**FOR: VILLE PLATTE FIRE DEPARTMENT  
CENTRAL FIRE STATION  
ADDENDUM NUMBER 2**

## ADDENDUM NO. 2

### TO THE PLANS AND SPECIFICATIONS FOR THE VILLE PLATTE FIRE DEPARTMENT CENTRAL FIRE STATION

May 13, 2026

## DETAIL – GREASE TRAP

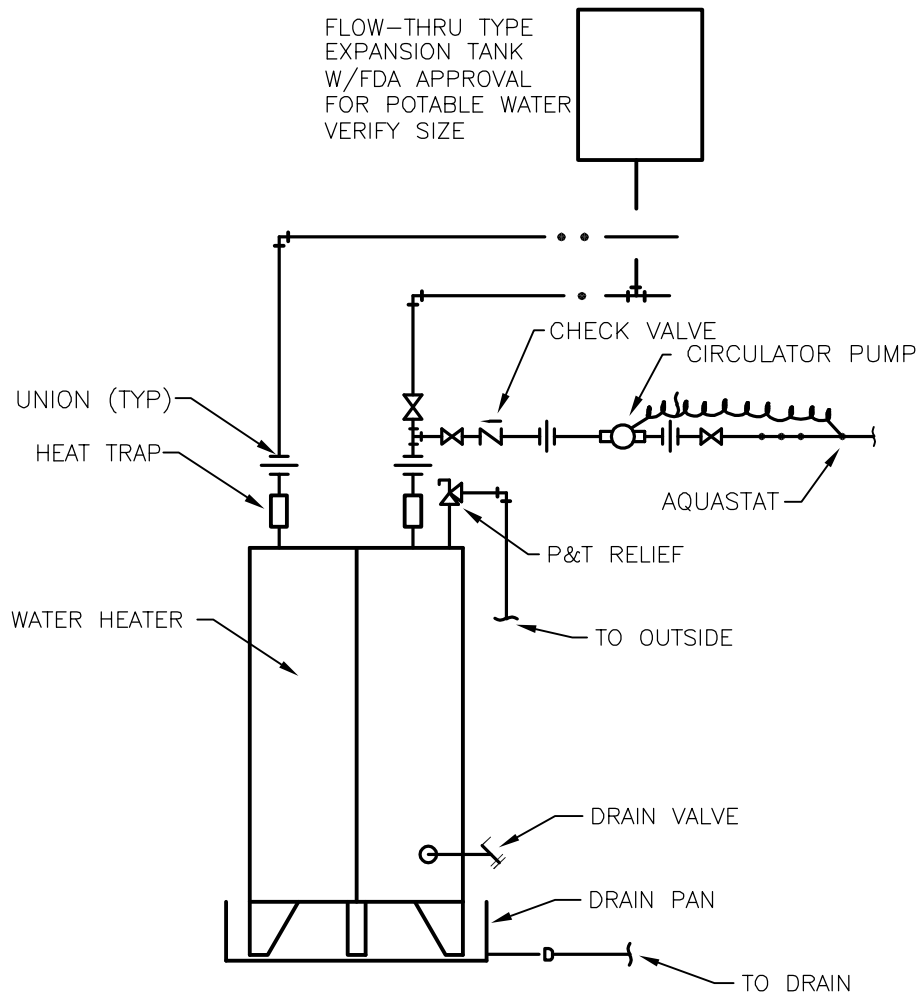
34. Sheet M2 – Reference attached grease trap detail. See **ATTACHMENT No. 4.**
35. Sheets M2 and M3 – Reference attached water heater detail. See **ATTACHMENT No. 5.**

SHALL BE IN STRICT ACCORDANCE W/ CITY OF VILLE PLATTE  
REQUIREMENTS. VERIFY LOCATION AND SIZE.

**C2**

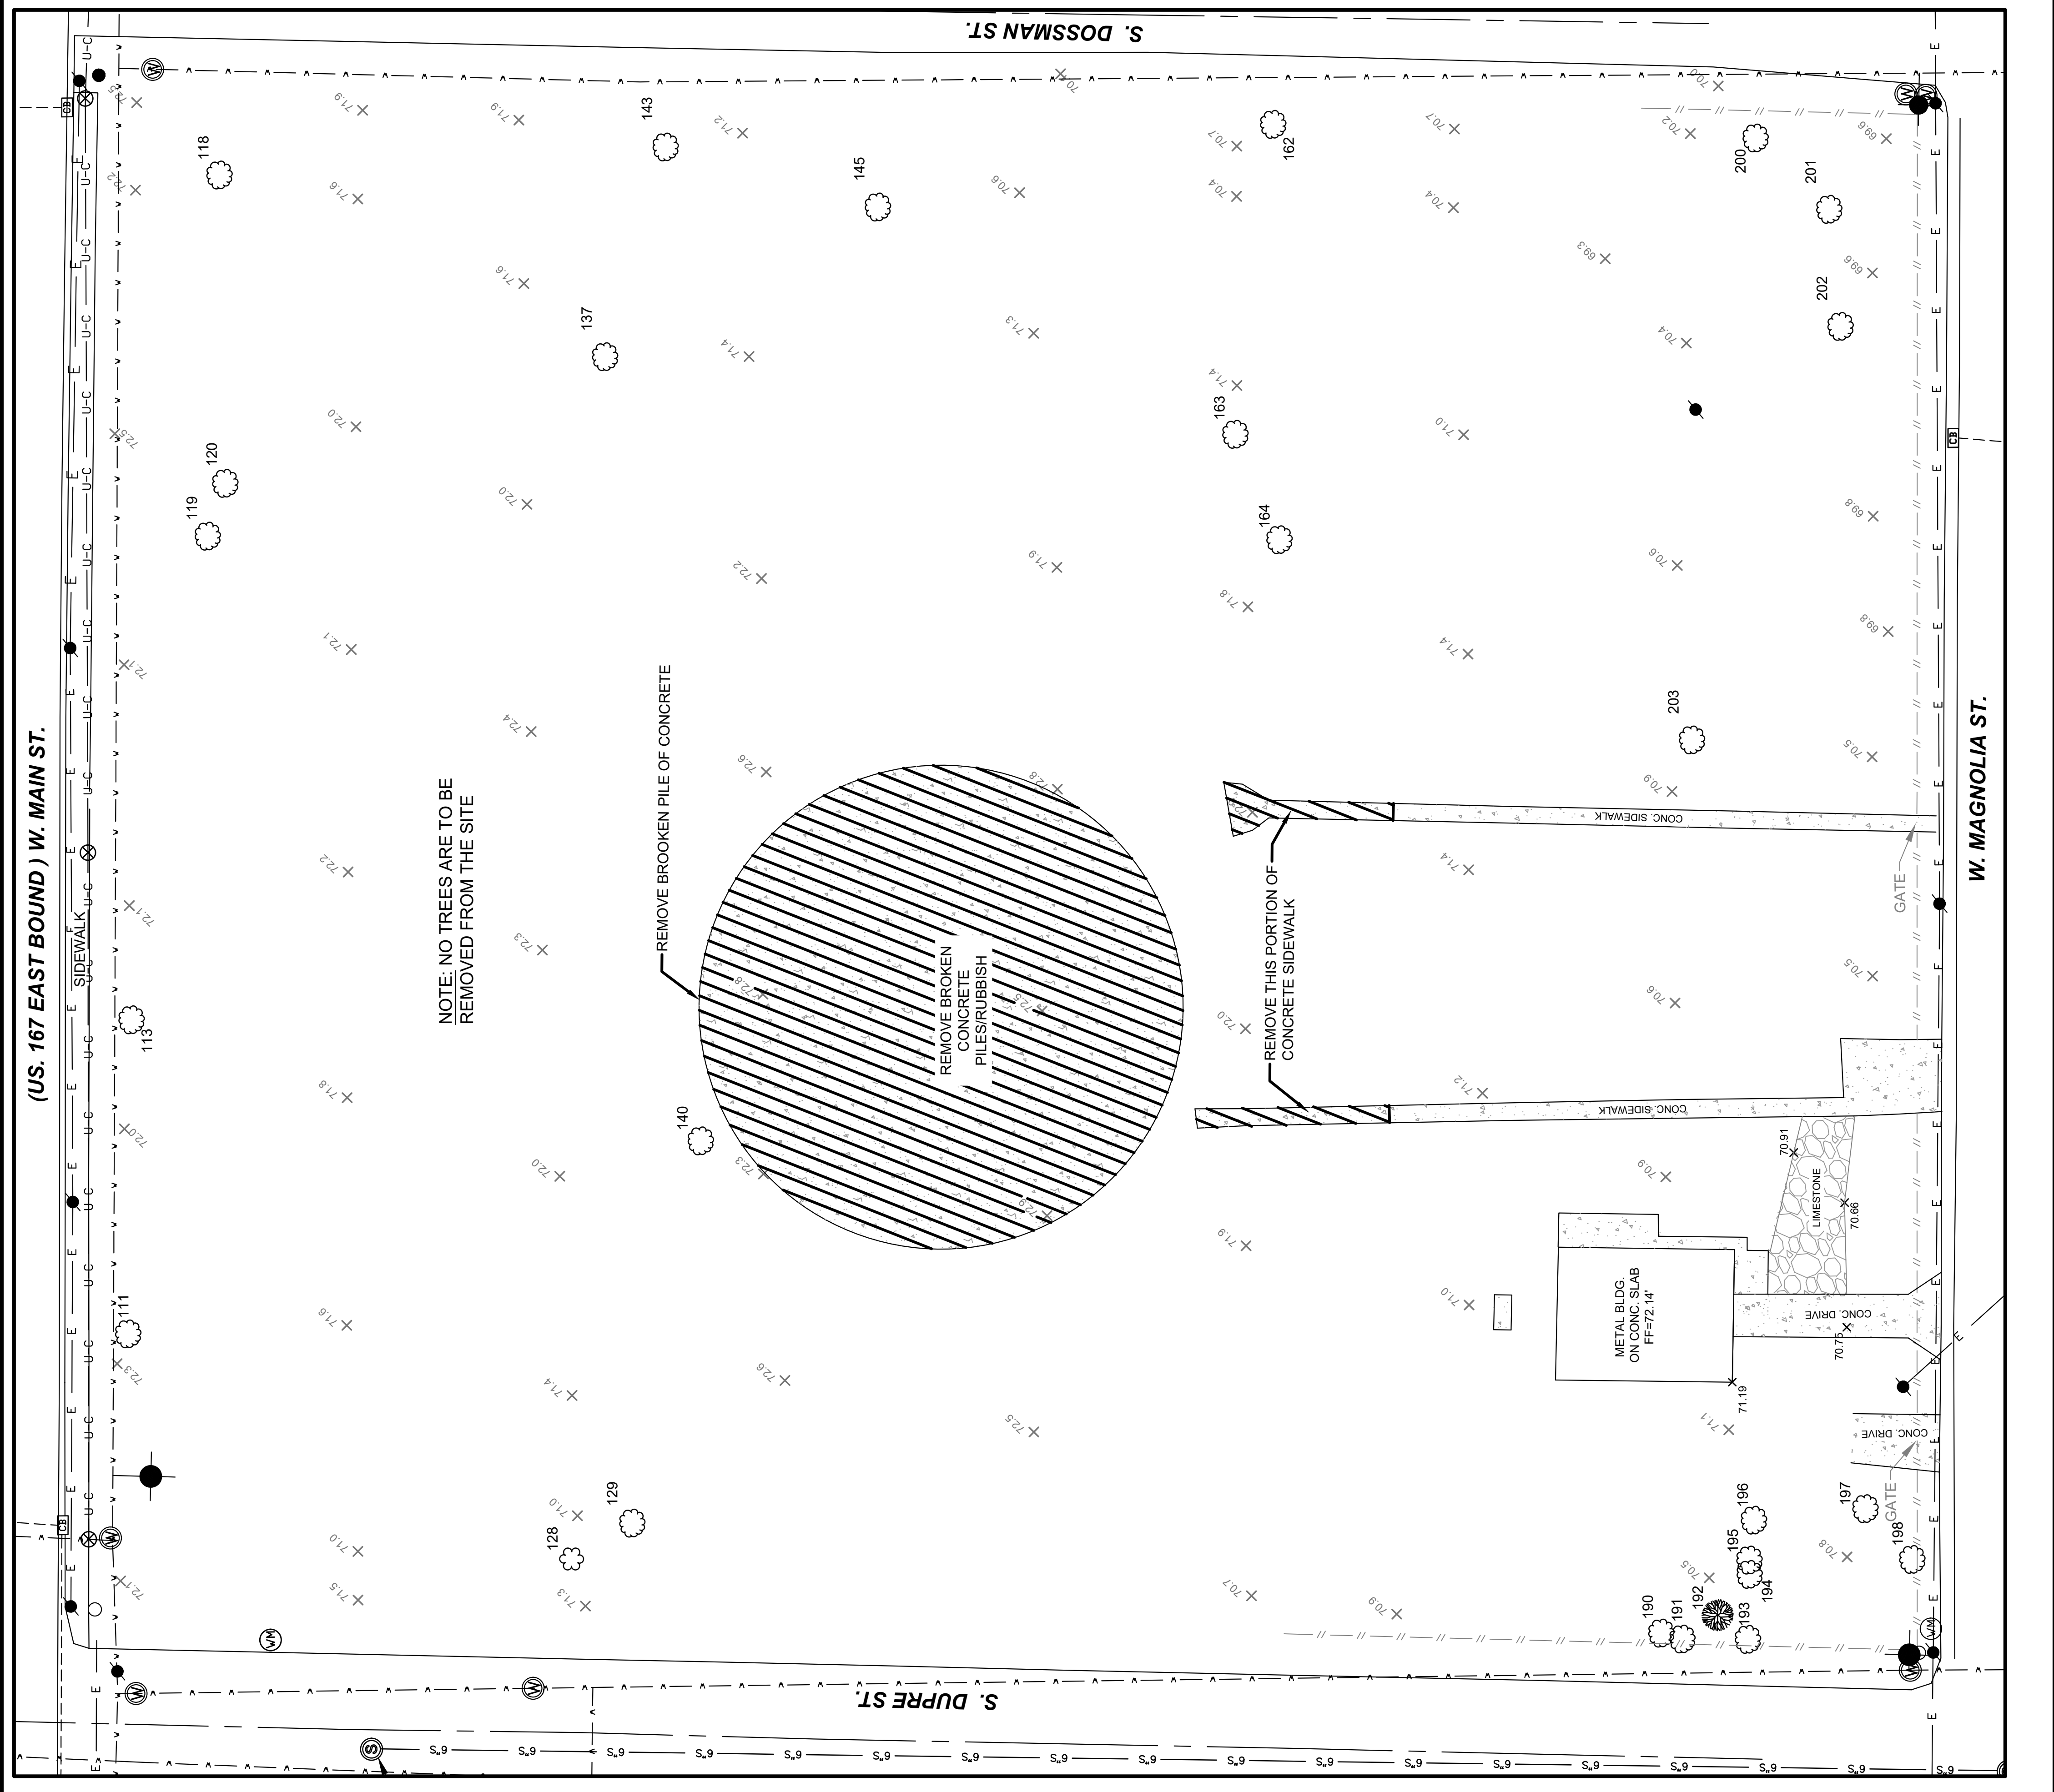
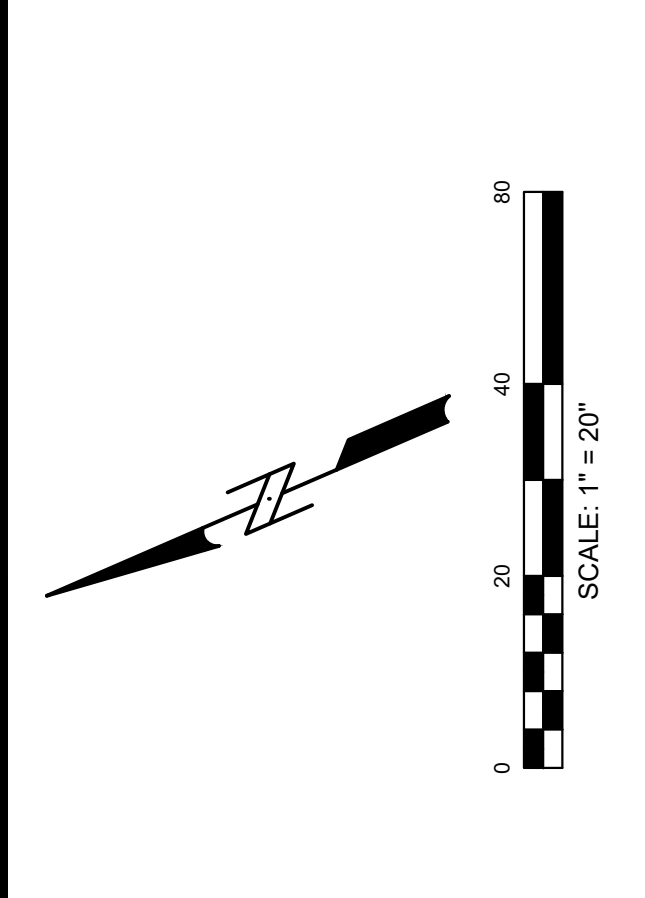
1. Sheet C2 Demolition plan – No trees are to be removed from the site. The removal process was ongoing, therefore any tree/trees shown to be in conflict with the building, paving, etc. has been removed. Note added to sheet C2, “No trees are to be removed from the site”. See **ATTACHMENT No. 6**.

NOTE: NO TREES ARE TO BE REMOVED FROM THE SITE

ATTACHMENT No. 7

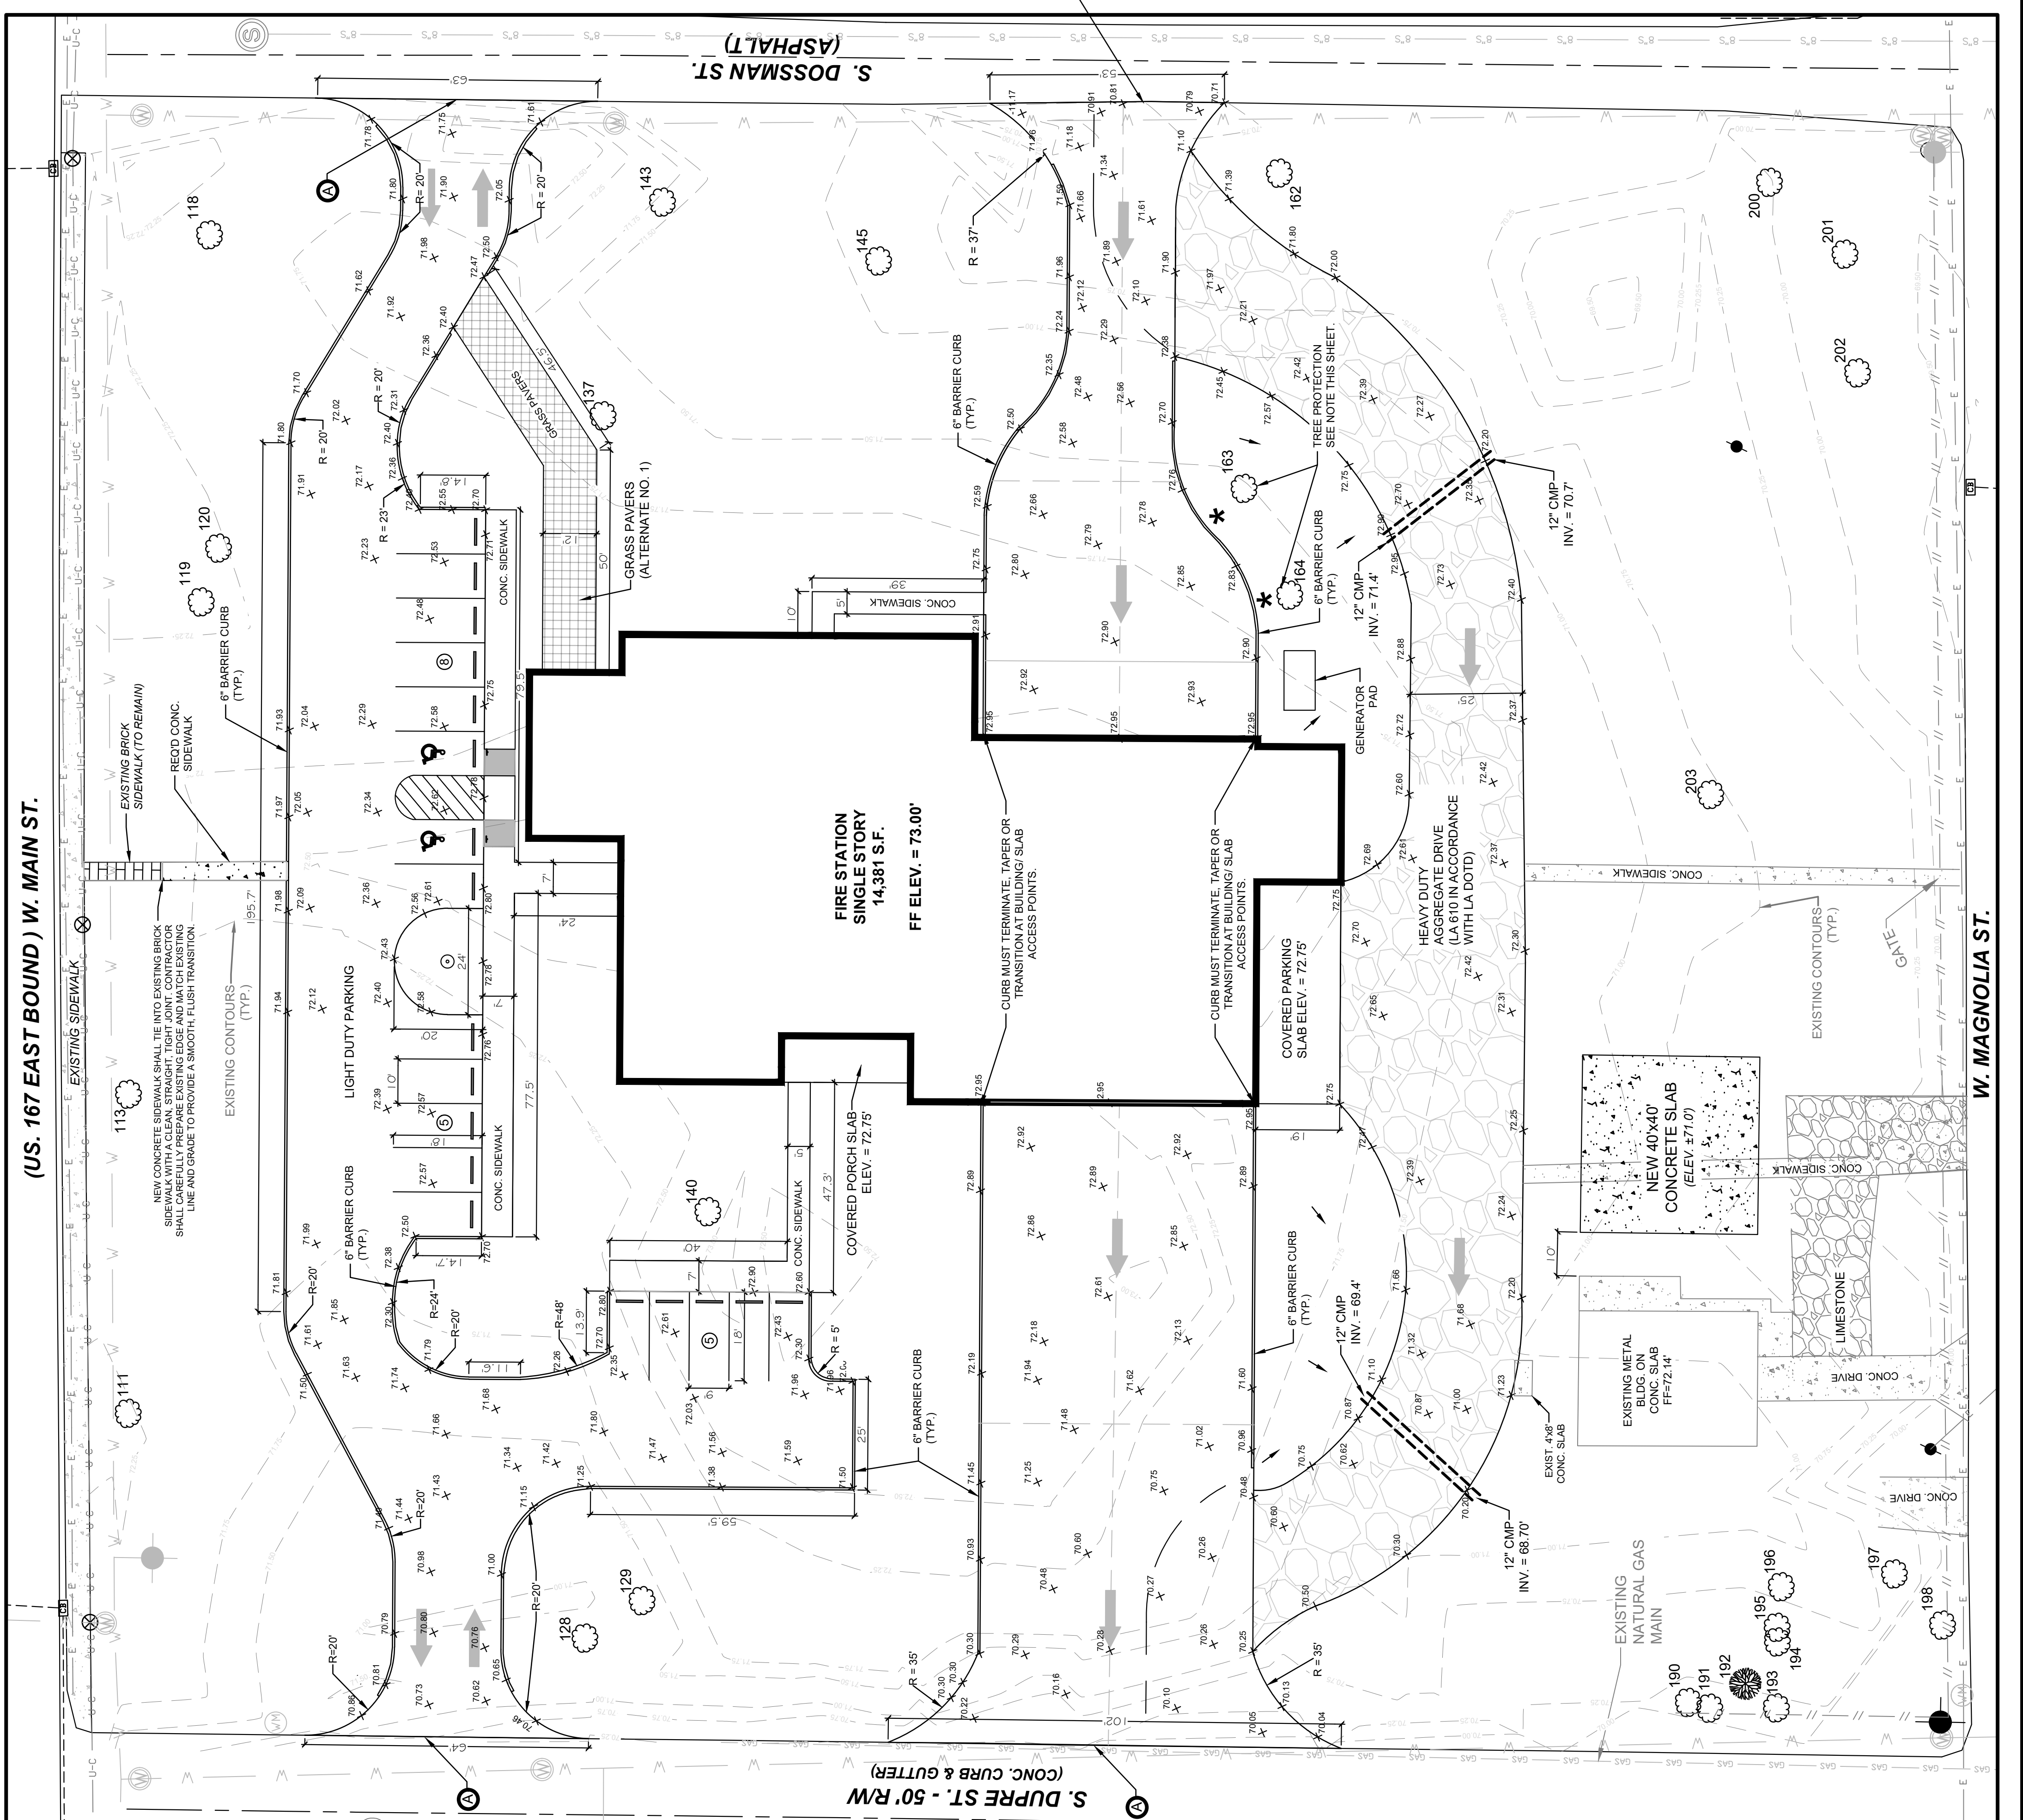
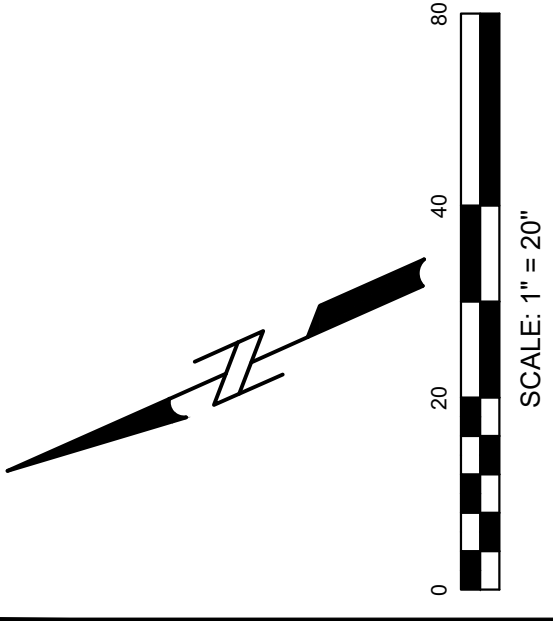
2. Sheet C3 Grading Plan - Tree protection fencing is required around Trees 163 and 164 only, although caution should be taken around existing trees on the site. See **ATTACHMENT No. 7**.

3. Sheet C3 Grading Plan - Heavy Duty Aggregate Drive shall be LA 610 in accordance with LA DOTD. Note added to sheet C3, “LA 610 in accordance with LA DOTD”. See **ATTACHMENT No. 7**.

4. Sheet C3 Grading Plan - Note added to sheet: “Elevations shall be interpreted as finished pavement / gutter flowline elevations adjacent to the curb, unless specifically labeled “TC,” “TOC,” or “Top of Curb.” The top of the 6" barrier curb shall be 0.50' above the adjacent finished pavement / gutter flowline elevation. The curb shall terminate, transition, or be omitted where required at building access points, covered slab tie-ins, sidewalk crossings, curb openings, and other locations where a flush transition is required. Contractor shall maintain positive drainage away from the building and shall notify the Engineer of any field condition that prevents construction of the grades shown.” Removal of elevations 7.09 and 73.32 on west side of parking lot. Note added to sheet C3, “curb must terminate, taper, or transition at building/slab/sidewalk access points”. See **ATTACHMENT No. 7**.

5. Sheet C3 and C5 - The paving section shown on Sheet C5 shall govern. Heavy duty concrete paving, including fire apparatus drives, aprons, and drive areas, shall be 8" thick Portland cement concrete reinforced with #4 bars at 12" O.C. each way, as shown in the paving details on Sheet C5. Light duty parking areas shall be 5" thick Portland cement concrete with welded wire reinforcement, not #4 rebar. Reinforcement shall be welded wire mesh/fabric as indicated in the concrete paving details and general concrete notes. Note 6 revised on sheet C3 to read, “Heavy duty Portland cement concrete paving shall be 8 inches thick with #4 reinforcing bars at 12 inches O.C. each way, per Sheet C5 paving details. Light duty Portland cement concrete paving shall be 5 inches thick with welded wire reinforcement. See Sheet C5 for paving, jointing, curb, and edge details. See geotechnical report for fill, subgrade preparation, stabilization, and base requirements.” See **ATTACHMENT No. 7**.

- CONTRACTOR SHALL PROVIDE SMOOTH TRANSITIONS BETWEEN PAVEMENT, SIDEWALKS, AND AGGREGATE DRIVE AREAS.
  - BEARS AT 12 INCHES O.C. EACH WAY. PER SHEET C5 PAVING DETAILS. LIGHT DUTY PORTLAND CEMENT CONCRETE PAVING SHALL BE 5 INCHES THICK WITH WELDED WIRE REINFORCEMENT. SEE SHEET C5 FOR PAVING, JOINTING, CURB, AND EDGE DETAILS. SEE GEOTECHNICAL REPORT FOR FILL, SUBGRADE PREPARATION, STABILIZATION, AND BASE REQUIREMENTS.

- SPOT ELEV. NOTE:**
- SPOT ELEVATIONS SHOWN ALONG CURB LINES REPRESENT FINISHED PAVEMENT / GUTTER FLOWLINE ELEVATIONS ADJACENT TO CURB. UNLESS SPECIFICALLY LABELED "TC," "TOC," OR "TOP OF CURB," TOP OF 6" BARRIER CURB SHALL BE 0.50' ABOVE ADJACENT FINISHED PAVEMENT / FLOWLINE ELEVATION. CURB SHALL TERMINATE OR TRANSITION AS REQUIRED AT SIDEWALKS, BUILDING ACCESS POINTS, COVERED SLAB TIE-INS, CURB OPENINGS, AND OTHER FLUSH TRANSITION LOCATIONS.

- TREE PROTECTION NOTE:**
- EXISTING TREE TO REMAIN SHALL BE PROTECTED DURING CONSTRUCTION. PRIOR TO ANY WORK IN THIS AREA, CONTRACTOR SHALL SUBMIT PROPOSED TREE PROTECTION MEASURES FOR REVIEW. INSTALL PROTECTIVE FENCING PRIOR TO CONSTRUCTION. NO GRADING, EXCAVATION, STOCKPILING, OR EQUIPMENT TRAFFIC SHALL BE ALLOWED WITHIN TREE PROTECTION AREA. CONTRACTOR SHALL BE RESPONSIBLE FOR ANY DAMAGE.
